Dear editor and reviewers,

Authors Response (AR) to RC #1

Figure R1a.. Source image from Town of Gilbert, AZ (2022)

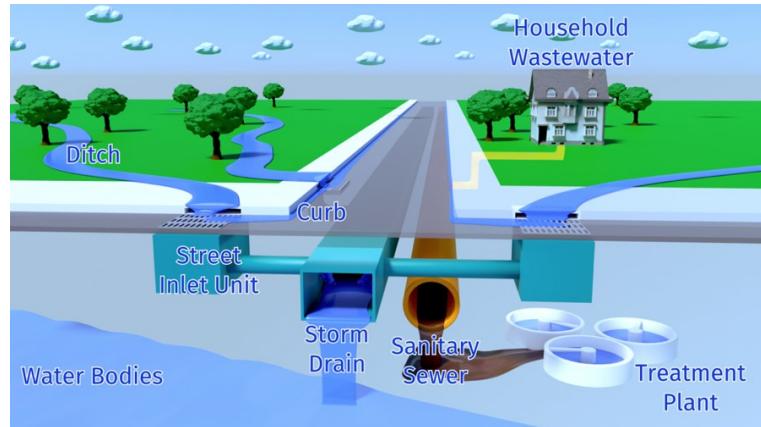
11. Is Figure 1 an original creation or is it obtained from other sources? Please ensure that IP is not infringed.

AR: This figure is adapted from Town of Gilbert, AZ (2022) but with substantial modifications. We added reference to the original figure to Figure 1's caption ([Page 3](#)) Below in Figure R1 please see the comparison between the original version and our version.

Figure R2: sensitivity analysis of the threshold value.

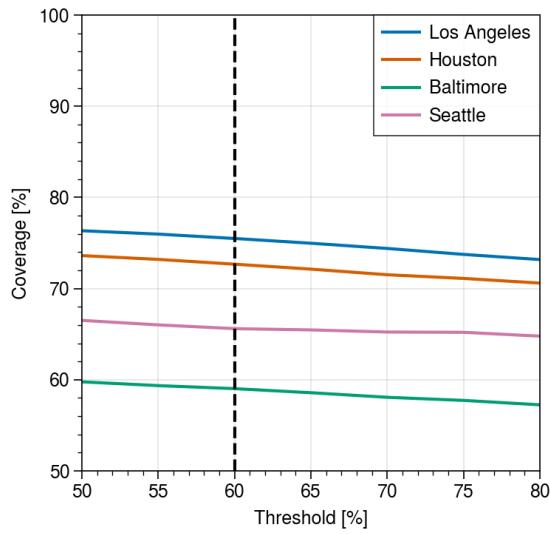
6. *Line 159: "60% of a pipe length from the real BUSN is within this buffer zone, the pipe is considered "covered". Did authors consider other values as the criteria? I'm curious how sensitive this criteria would be.*

AR: Yes, we tested the model sensitivity to this threshold using threshold values ranging from 50-80% and the difference in the total coverage percentage was in the order of 1%. So, the model is not very sensitive and we opted for using 60%. Below Figure R2 shows a comparison of the coverage percentage for the four case studies and with different threshold values between 50 and 80 percent with a step size of 5%. We added a note on this on **Lines 214-215**.
